Agenda
Aurora Planning Commission Meeting
 Tuesday, June 4, 2024 at 7 P.M.
 City Council Chambers, Aurora City Hall
 21420 Main Street NE, Aurora, OR 97002

Site Development Review Application City Case File SDR 24-01

STAFF REPORT: Site Development Review application city case file SDR 24-01
DATE: May 28, 2024, for the June 4, 2024, Planning Commission Meeting.

Figure 4: Applicant's Site Plan

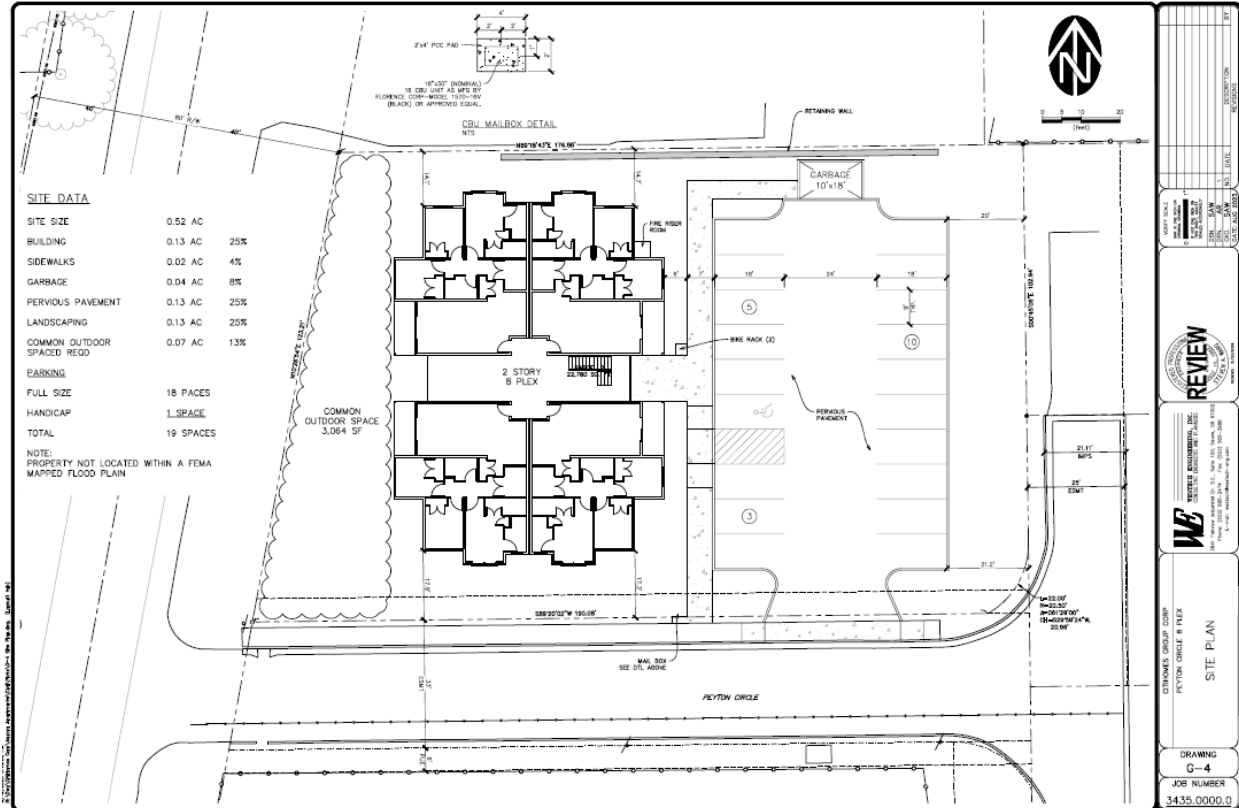
Findings: The proposal includes eight (8) units consisting of three bedrooms. The project requires 19 parking spaces which are provided as shown on the Applicant's site plan. The standard is met.

Findings: The minimum dimensional standard for 90-degree parking spaces is 9'6" x 20'. The Applicant's site plan shows parking spaces with 9 feet of width and 18 feet of depth.

The depth dimension is measured from the front of the outer curb to the edges of the vehicle access aisle. The site plan accommodates two feet of overhang without parked vehicles interfering with any pedestrian circulation area. Therefore, staff can find the depth dimension is met with the 18 feet shown plus 2 feet of overhang. The width dimension is required to be met with a recommended condition of approval. The standard can be met as conditioned.

Figure 5: Fire Access Plan

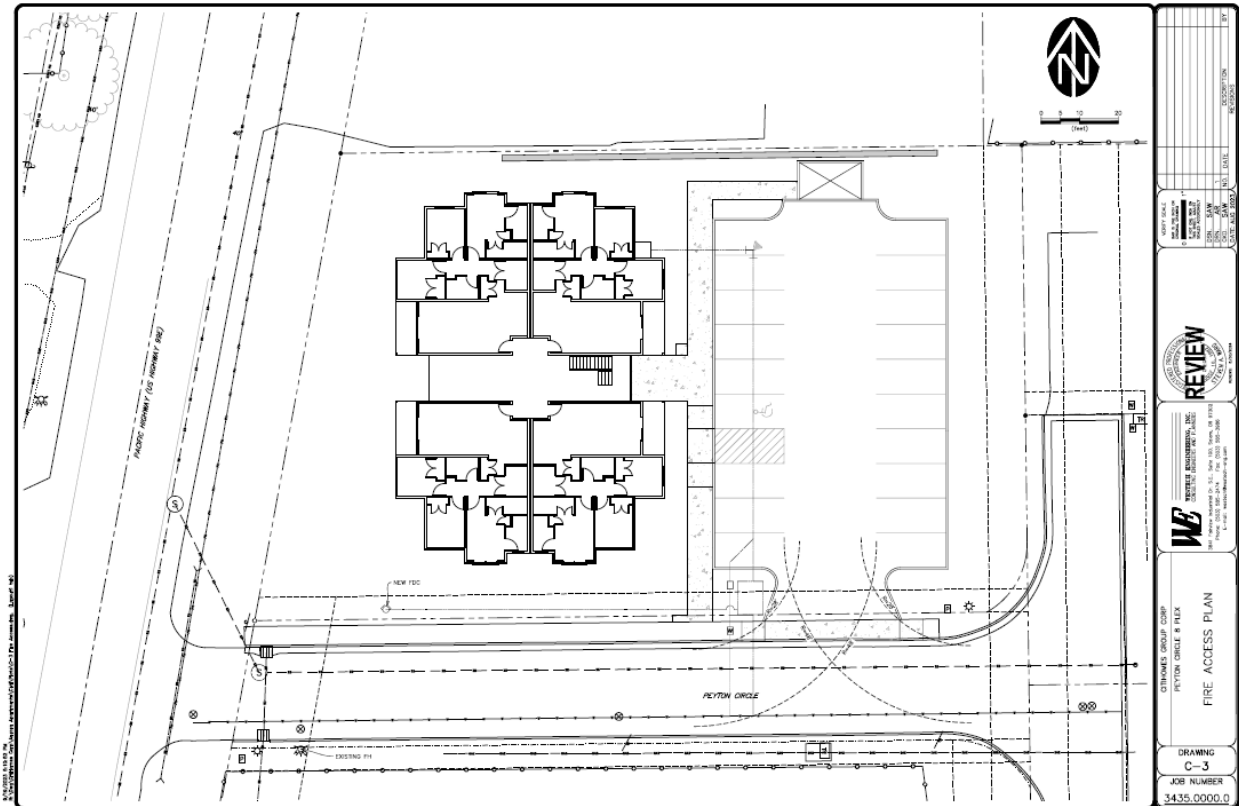
Findings: The development is served by existing access from Highway 99E, permitted through an existing highway approach permit (#52512) as well as a reciprocal access easement contained on property to the south. ODOT comments on the application in Exhibit A.7 reasserted their comments from a previous approval that the development must use Peyton Circle for access and additional access to 99E would not be allowed. The Applicant provided the Fire Access Plan shown in Figure 5 showing how the development will provide access for emergency vehicles. The Applicant's plan was sent to the Fire Department for review and comment on March 7. The Fire Department did not submit comments on the application. Conditions of approval are recommended to ensure that the final development plan meets applicable fire access requirements. Staff find this criterion can be met as conditioned.

Figure 5: Proposed Landscape Planting Plan

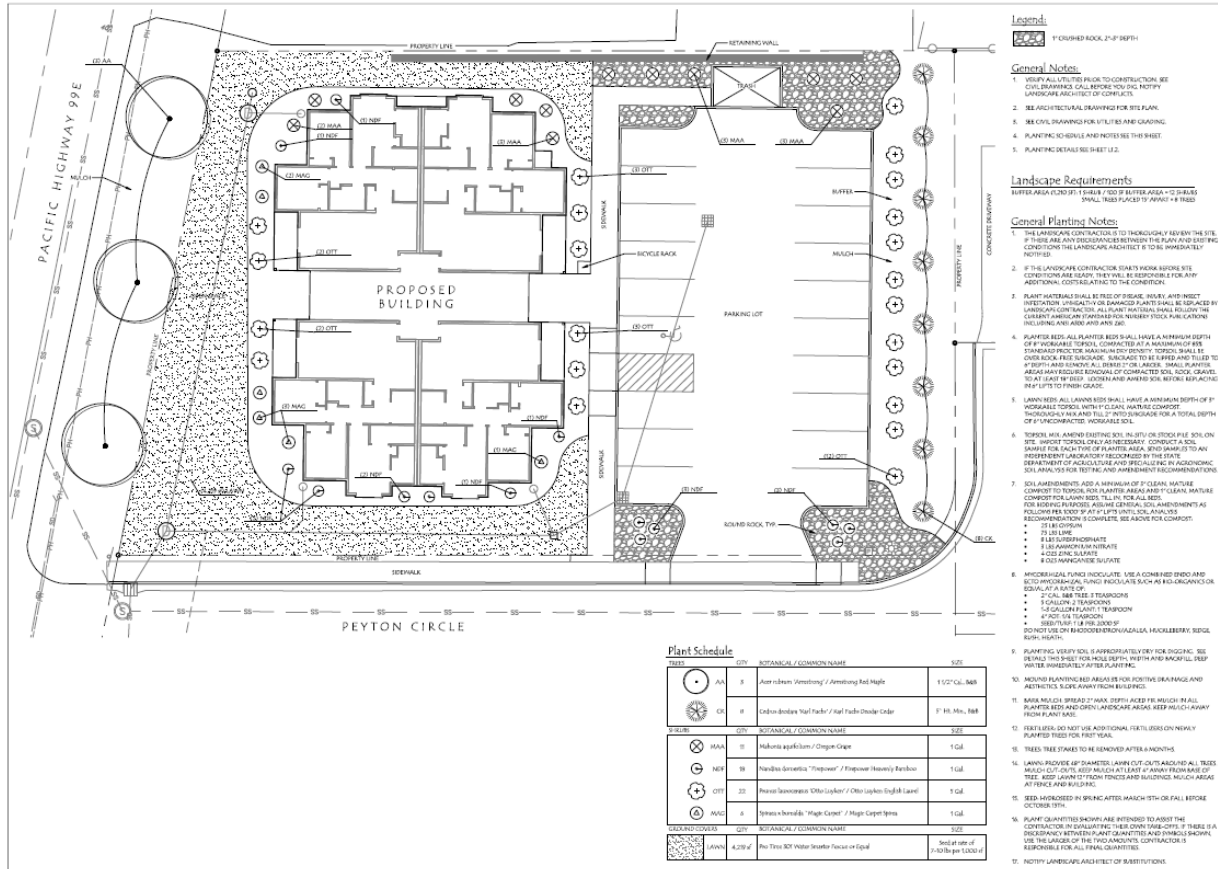
The Applicant submitted the Landscape Planting Plan shown in Figure 6 illustrating how landscaping is planned to be designed.

Findings: This minimum improvement standard applies to the setback area abutting the R-1 district along the eastern boundary of the property required by AMC 16.14.040.C.3. This screening requirement can be met with a recommended condition of approval requiring the Applicant to submit a revised landscape planting plan that includes one of the screening elements above. This standard can be met as conditioned.

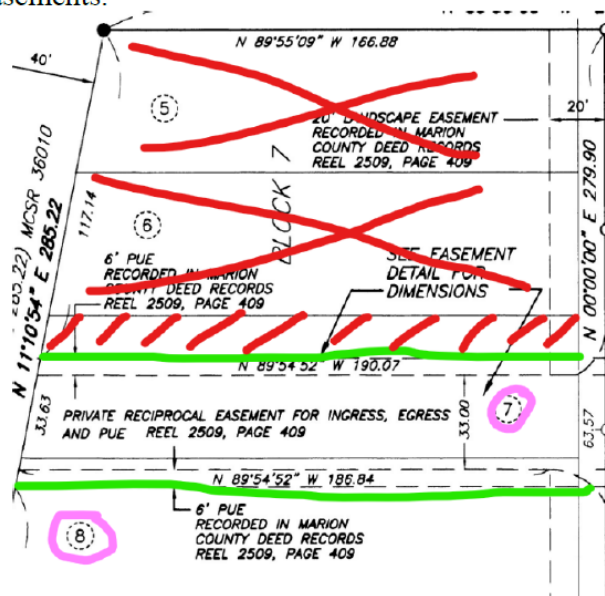
Further, Amendment paragraph #3 that creates the “Stormwater Easement” says it is for the “Impervious surfaces in the Original Easements [that] generate stormwater . . .” and that *An easement for the conveyance, discharge, treatment and detention of stormwater is hereby granted for the benefit of . . . [the hammerhead easement part of the four Peyton Circle lots] and for the benefit of those portions of Lots 7 and 8, Block 7, Snyders Addition that are within the Original Easements.*

Staff response: Staff agrees that the stormwater maintenance agreement contained in Reel 4225 Page 247 does not describe the area outside the original easements as benefitting from the stormwater easement. Staff also observes that none of the residential lots, including Lots 1-4 of Peyton Circle are described as benefitting. Section 8 of Reel 2509 Page 409 MCDR describes the process for resolving disputes between the lot owners.

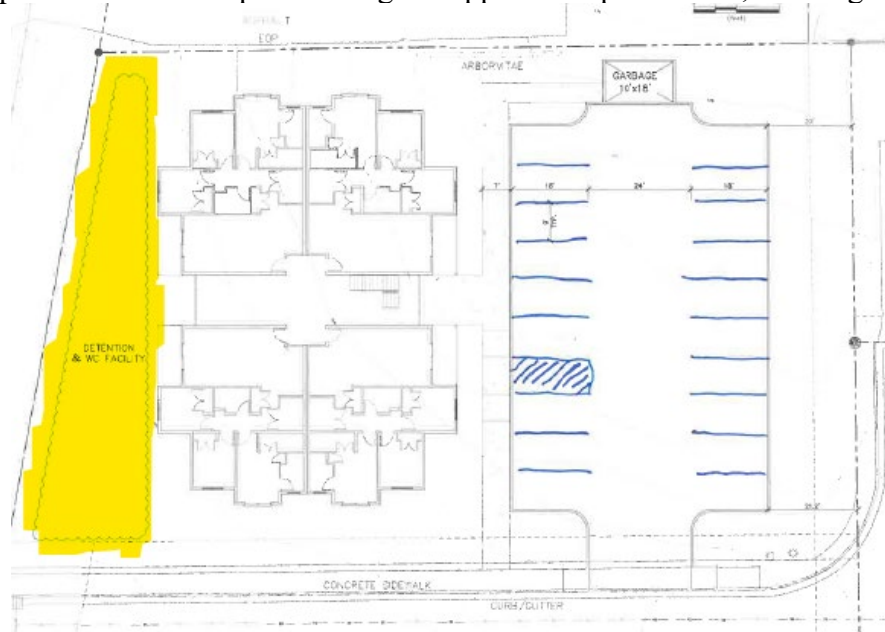
Staff response: See previous responses explaining why AMC 16.34.030(C)(1) does not apply. Planning Commission approved the creation of Peyton Circle in 2002 subject to the Condition of Approval that Planning Commission deemed necessary to carry out the applicable criteria for approving private streets that were in place at the time of the decision.

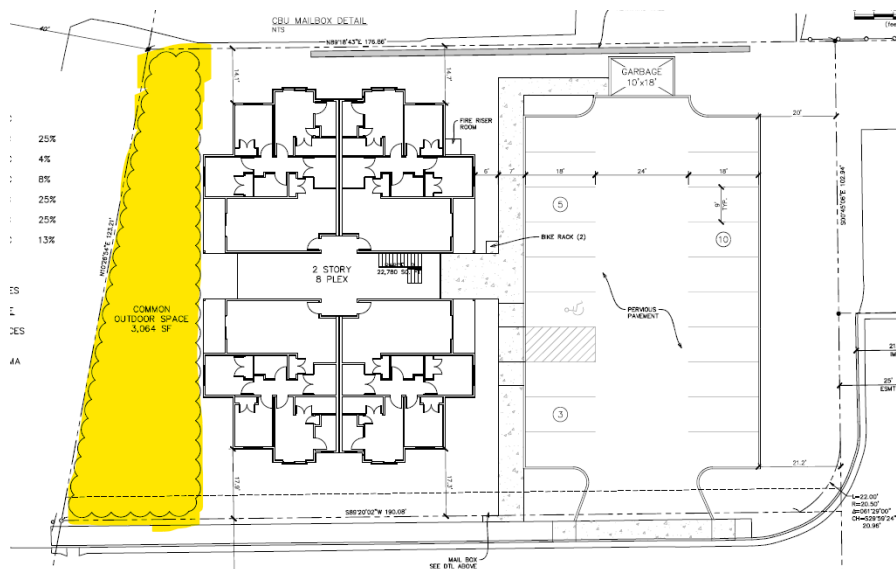
Staff response: Single-family homes are not permitted as a stand-alone use in the Neighborhood Commercial Overlay or in the underlying Commercial Zone. The Commercial Zone only permits a single-family residence as an accessory structure that cannot be sold separately. The project is subject to the Gateway Development Standards and the development standards of the Neighborhood Commercial Overlay which are intended to ensure that development is compatible with the City's architectural and aesthetic character. Those standards have been incorporated into the recommendation to the maximum extent possible for a housing project subject to ORS 197.307(4), which states that a local government may adopt and apply only clear and objective standards, conditions and procedures regulating the development of housing, and the standards, conditions, and procedures may not have the effect, either in themselves or cumulatively, of discouraging needed housing through unreasonable cost or delay.

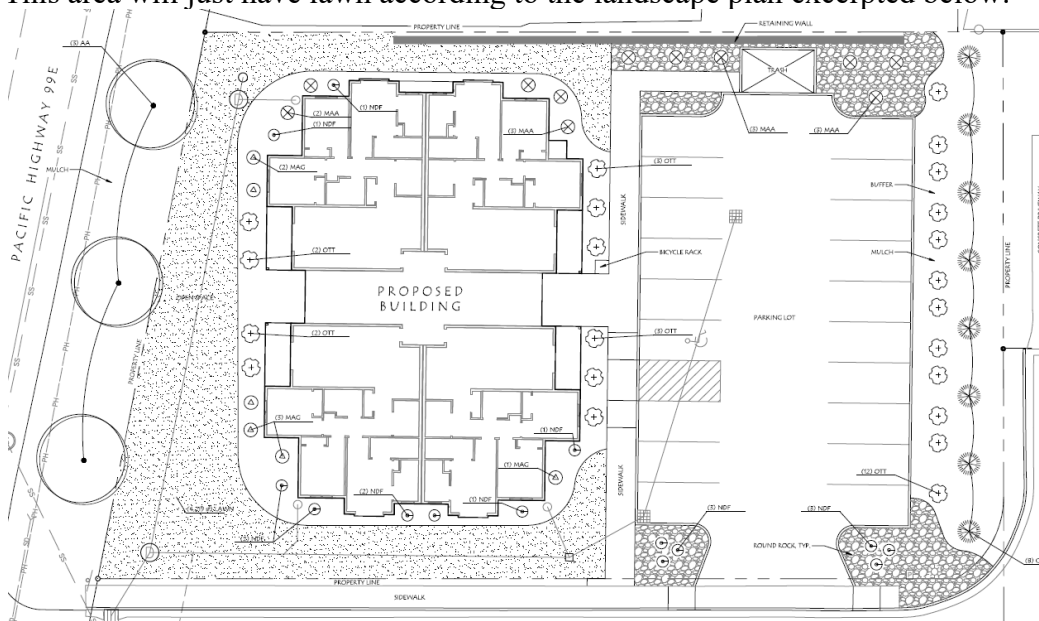
The purpose of Apartments is to house big populations which in this circumstance does not seem necessary for such a small town. Aurora as we know is recognized to have a small population. In fact, in 2021 the population was a small number of 1,144 residents. We believe that constructing apartments will bring more people, more noise, and the risk of a higher crime rate. As a neighborhood we all have security cameras on our property because we all have many valuables. Some of us including ourselves have businesses, and many of our tools and equipment are on our property therefore adding an apartment complex right in front of our home definitely brings concerns.

Staff response: Multifamily (four units or more) containing no more than eight units per building outside the historic residential overlay in the base commercial zone are permitted in the Neighborhood Commercial Overlay. The Commercial Zone includes standards for landscaping, buffering, and screening from neighboring residential developments to

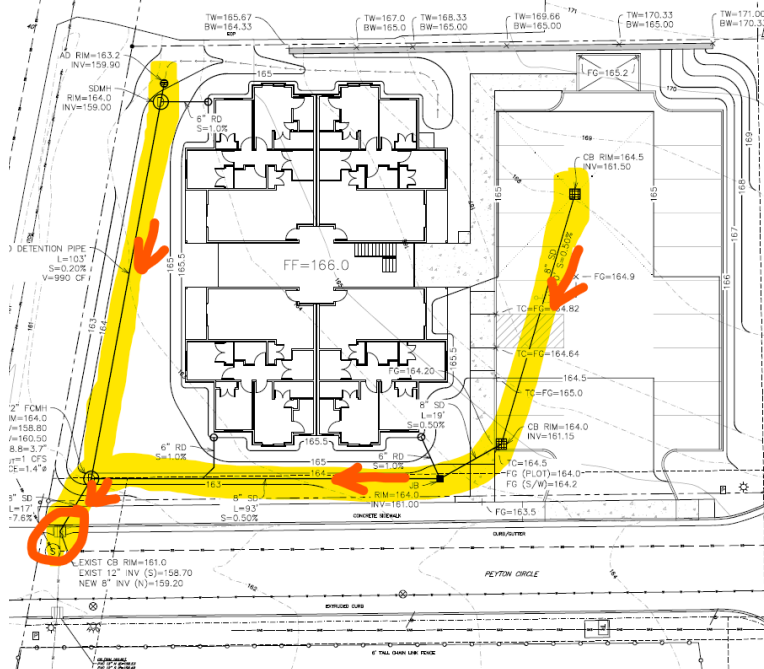
We were recently informed by our next door neighbor that we are apparently supposed to be paying the owner of the electrical business in our neighborhood a wastewater fee because the water goes into the parking lot. With the implementation of apartments, this will not only add the wastewater fee to our bills but will cause other utility bills to rise. Constructing these apartments will inevitably raise our security, protection, and utility bills. We believe there are a lot of things that have not been taken into consideration that will affect our small neighborhood. We understand if homes want to be built but constructing apartments seems unnecessary for our small town and neighborhood.

Staff response: Multifamily (four units or more) containing no more than eight units per building are permitted in the Neighborhood Commercial Overlay subject to Site Development Review. ORS 197.307(4), states that a local government may adopt and apply only clear and objective standards, conditions and procedures regulating the development of housing, and the standards, conditions, and procedures may not have the effect, either in themselves or cumulatively, of discouraging needed housing through unreasonable cost or delay. Detailed findings are provided throughout the staff report documenting these standards have been met or can be met as conditioned.
